SUNDRY NOTICES AND REPORTS ON WELLS
Do not use this form for proposals to drill or to re-enter an abandoned well. Use Form 3160-3 (APD) for such proposals.

8. Well Name and No. PRETTY GOOD 20 FED COM/603H

EOG respectfully requests an amendment to our approved APD for this well to reflect the following changes:

Pretty Good 20 Fed Com 714H (FKA 603H) API #: 30-025-51773

Revised Wellbore

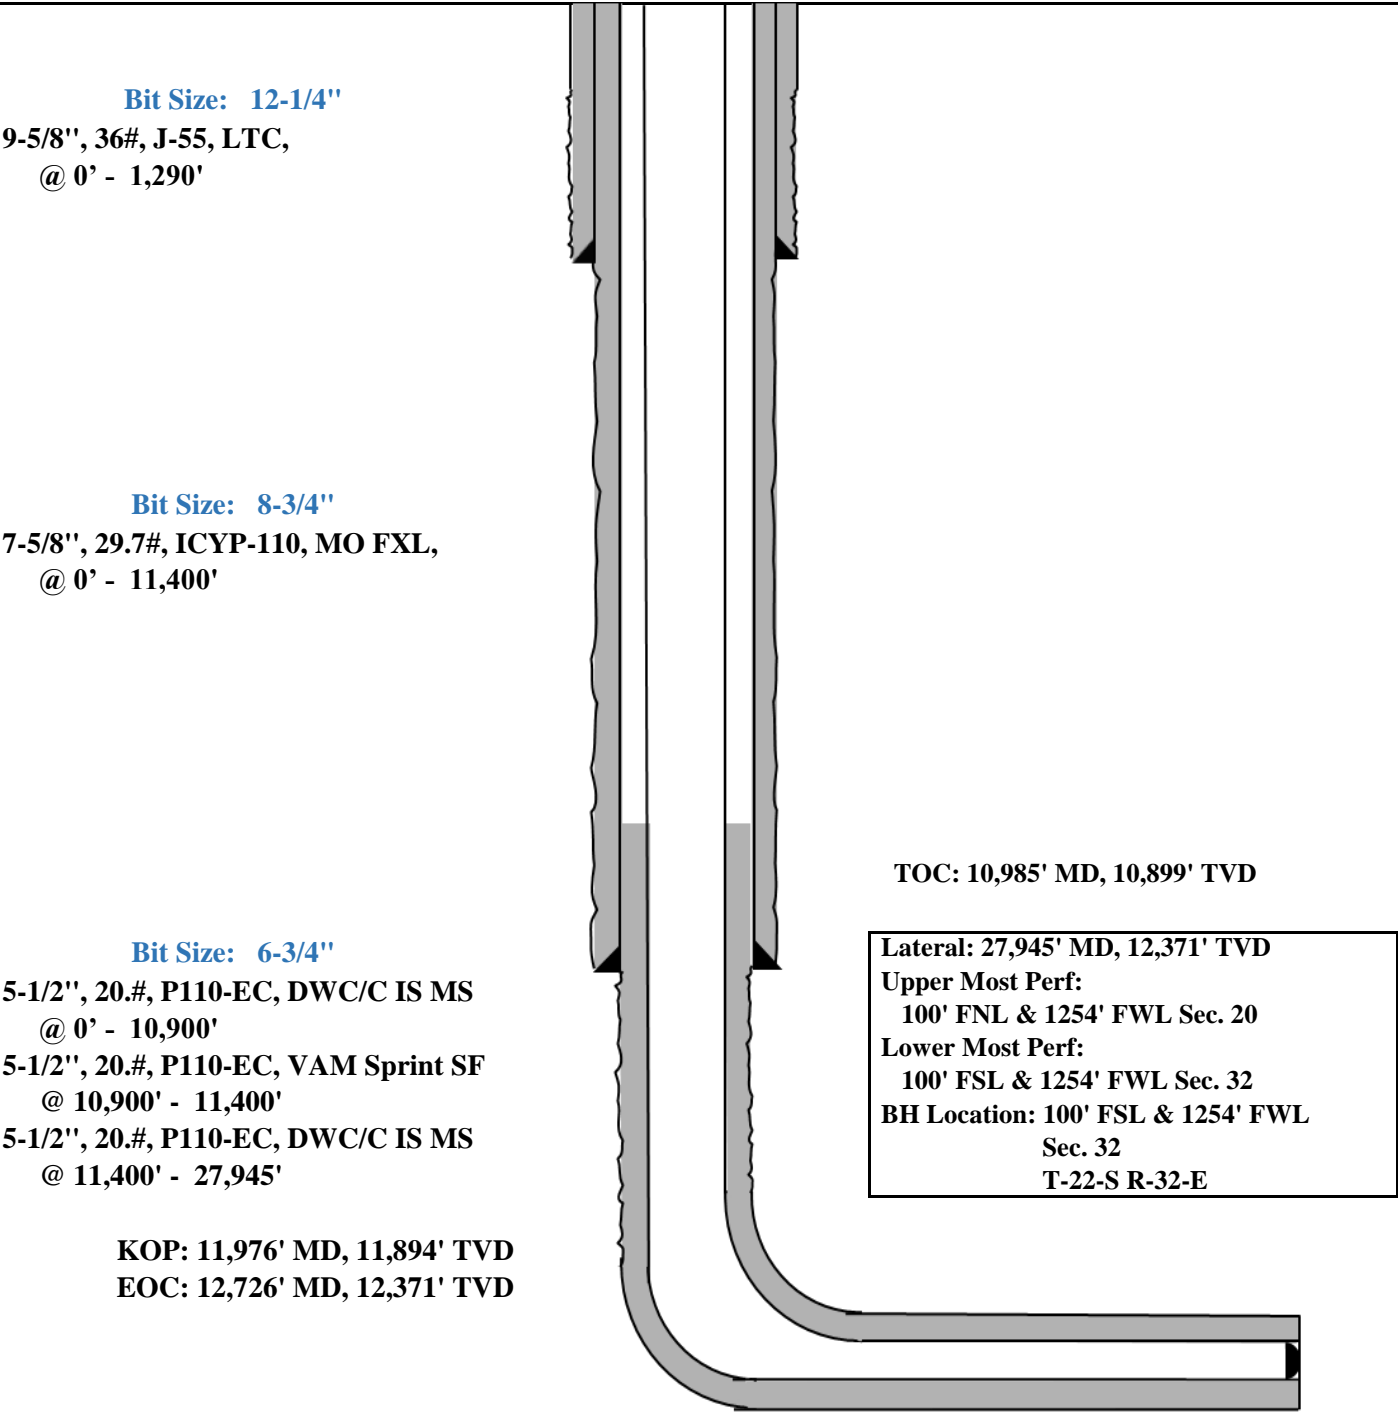
Bit Size: 12-1/4"
9-5/8", 36#, J-55, LTC,
@ 0' - 1,290'

Bit Size: 8-3/4"
7-5/8", 29.7#, ICYP-110, MO FXL,
@ 0' - 11,400'

Bit Size: 6-3/4"
5-1/2", 20.#, P110-EC, DWC/C IS MS
@ 0' - 10,900'
5-1/2", 20.#, P110-EC, VAM Sprint SF
@ 10,900' - 11,400'
5-1/2", 20.#, P110-EC, DWC/C IS MS
@ 11,400' - 27,945'

KOP: 11,976' MD, 11,894' TVD
EOC: 12,726' MD, 12,371' TVD

TOC: 10,985' MD, 10,899' TVD

Lateral: 27,945' MD, 12,371' TVD
Upper Most Perf:
100' FNL & 1254' FWL Sec. 20
Lower Most Perf:
100' FSL & 1254' FWL Sec. 32
BH Location: 100' FSL & 1254' FWL
Sec. 32
T-22-S R-32-E
